D240002: New Zealand Transport Agency Notice of Requirement SH 1 Rolleston Access Improvements

Request for further information

Title: LIGHTING CALCULATION PLAN
SHEET 2 OF 5

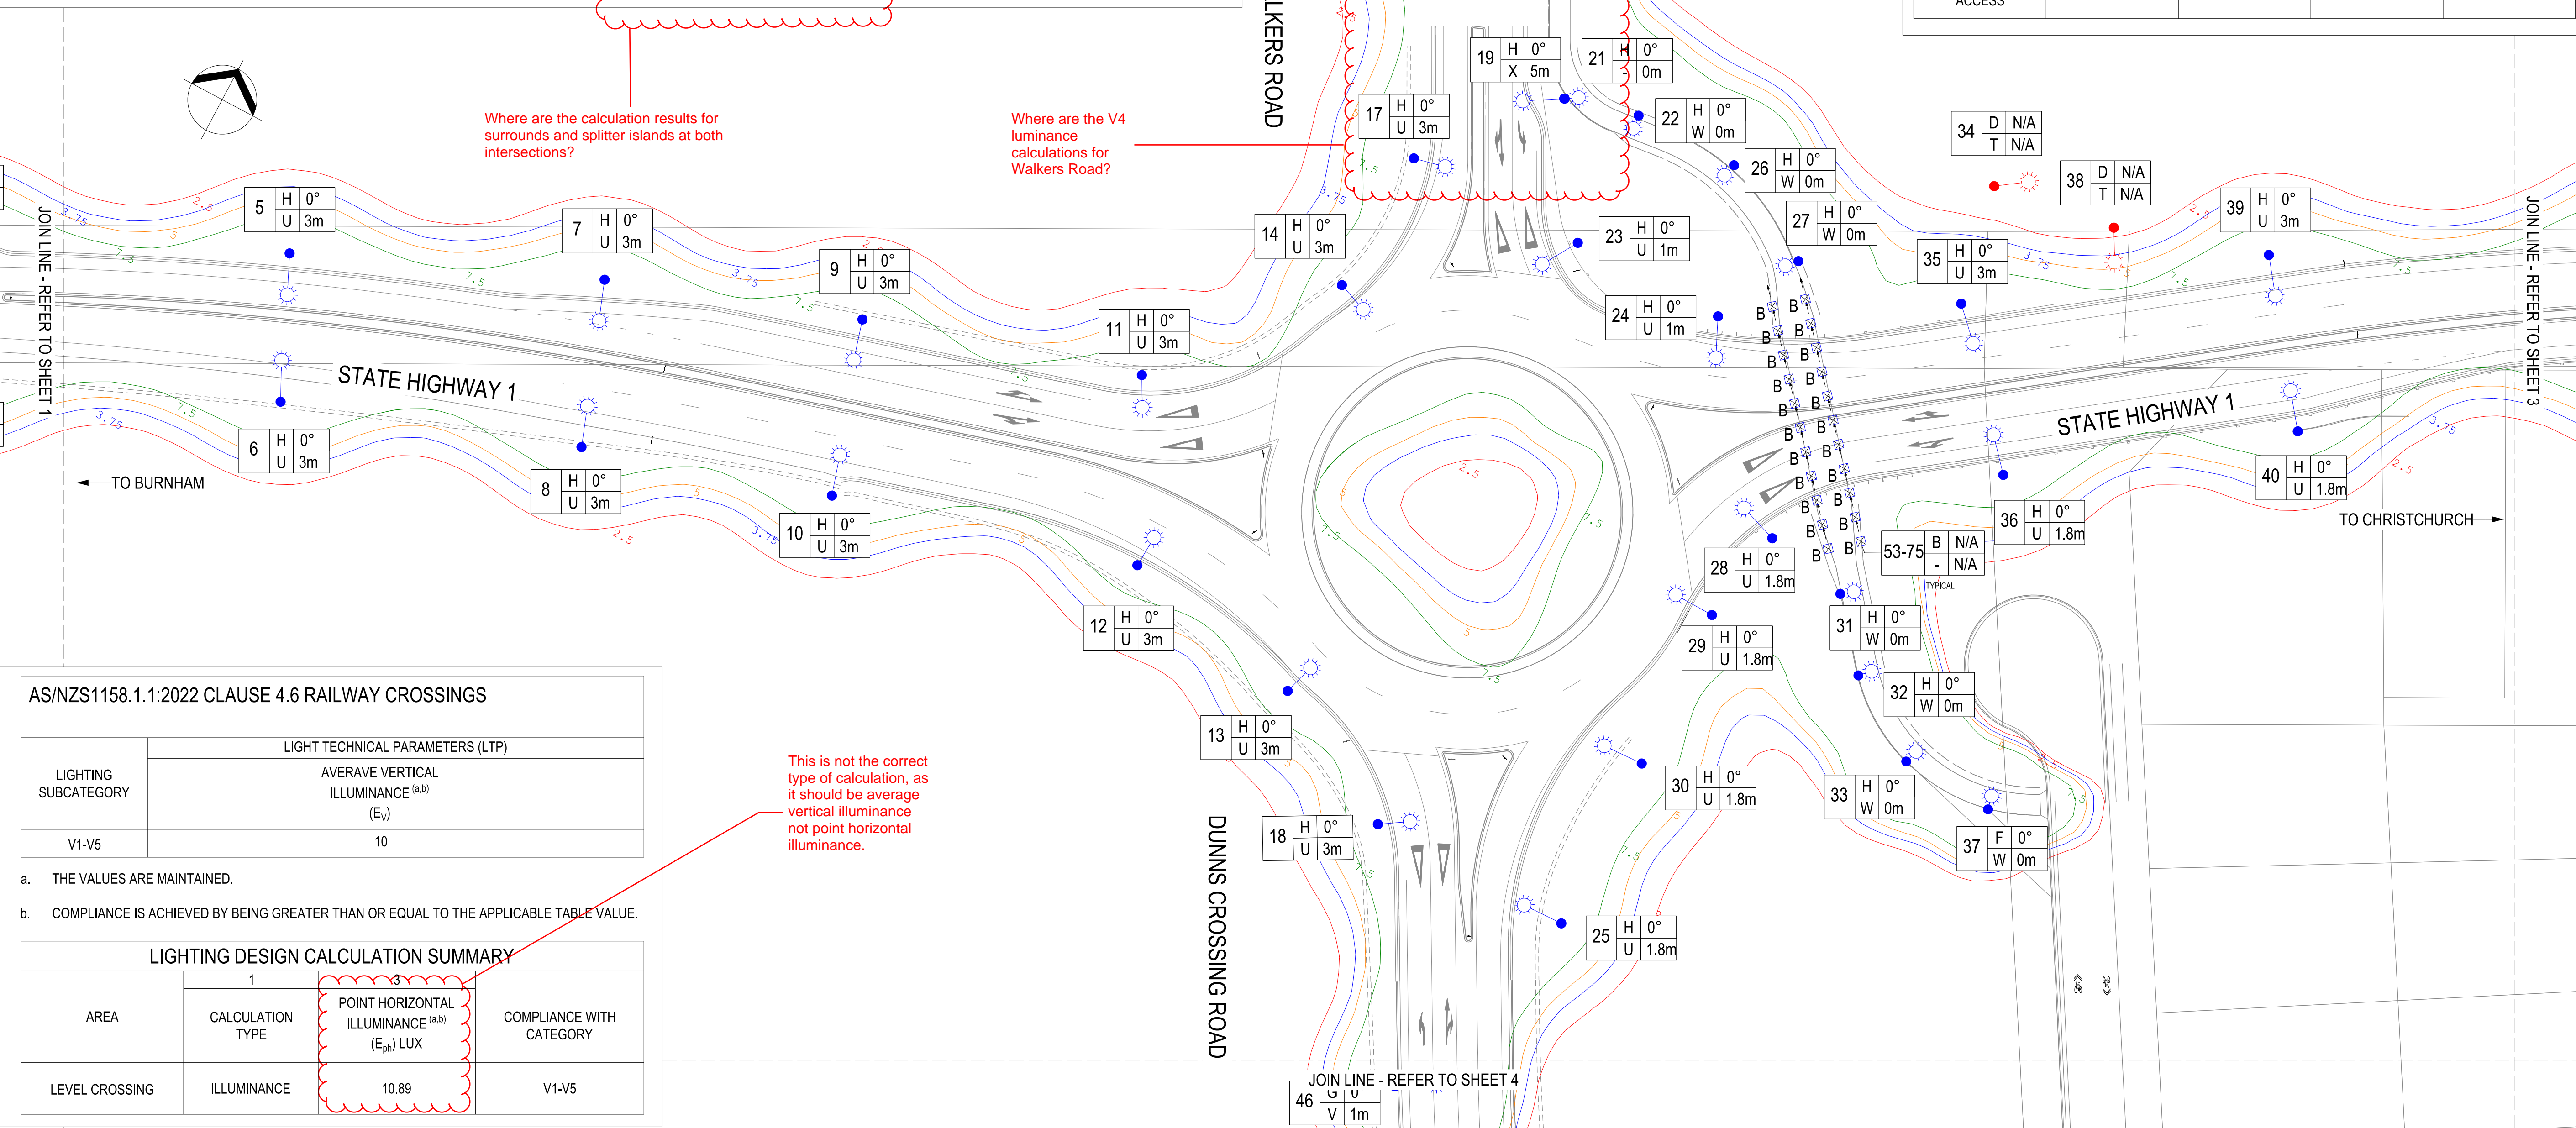
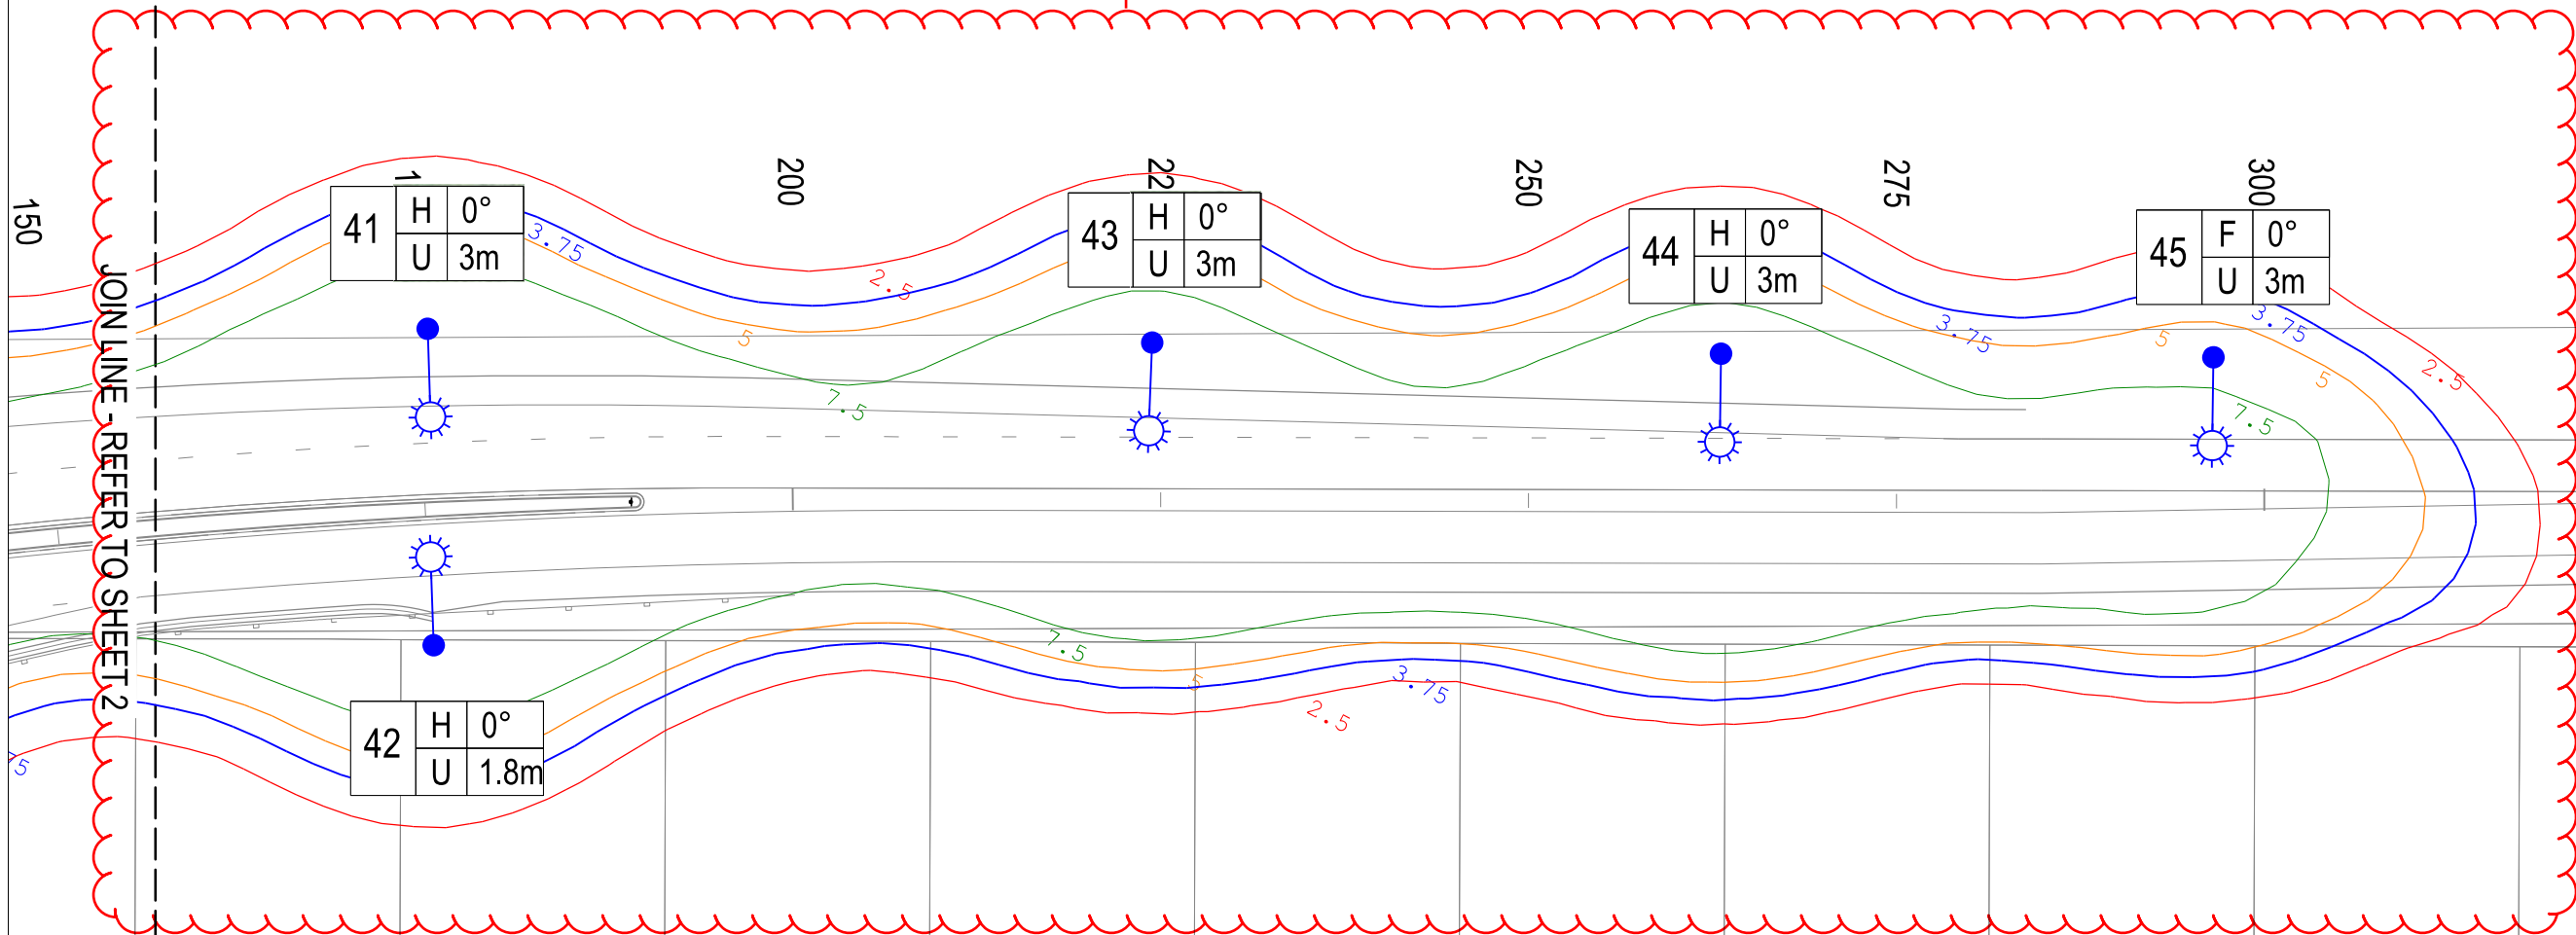
18. Drawing 3338703-10-CU-3522 - Calculation Table for Railway Crossings presents a point horizontal illuminance result of 10.89 Lux, however this is the wrong type of calculation for a rail level crossing. AS/NZS 1158.1.1 Section 4.6 requires an average vertical illuminance calculation (rather than a horizontal calculation) to be made for a single track and two-way traffic with the vertical plane and calculation points facing the oncoming traffic, so in this case there should be two sets of average vertical illuminance values. *This is a non-compliance with the standards so please get the lighting designer to complete average vertical illuminance calculations in accordance with AS/NZS 1158.1.1 Section 4.6.*

19. Drawing 3338703-10-CU-3522 - Locations of Poles 16 and 19 appear to be within 10m of the Kiwirail crossing boundary. The drawing does not show the rail crossing or boundary lines. AS/NZS 1158.1.1 Figure 4.17 provides a no column zone extending from the Kiwirail crossing boundary 10m in each direction from the crossing. *This appears to be a non-compliance with the standards so please get the lighting designer to move Poles 16 and 17 to be outside this no column zone or add the rail crossing boundary lines and dimensions to the drawing to demonstrate compliance.*

20. Drawing 3338703-10-CU-3522 - Illuminance Calculation Summary table only appears to include the carriageway areas. AS/NZS 1158.1.1 requires illuminance calculations at roundabouts and tee intersections that include the carriageway, surrounds and raised island design areas. *Please get the lighting designer to provide calculations for the surrounds and raised islands at both intersections in accordance with AS/NZS 1158.1.1 Figures 4.10 and 4.11.*

There should be separate luminance calculations for opposite and single sided arrangements

What lane configuration and luminaire arrangement does this calculation apply to? SH1 on either side of the RAB changes from 2-lane (either side of a raised median) down to single lane on each side of the median. There needs to be 2 calculation for each lane configuration. The luminaire arrangement also changes from opposite to single sided.
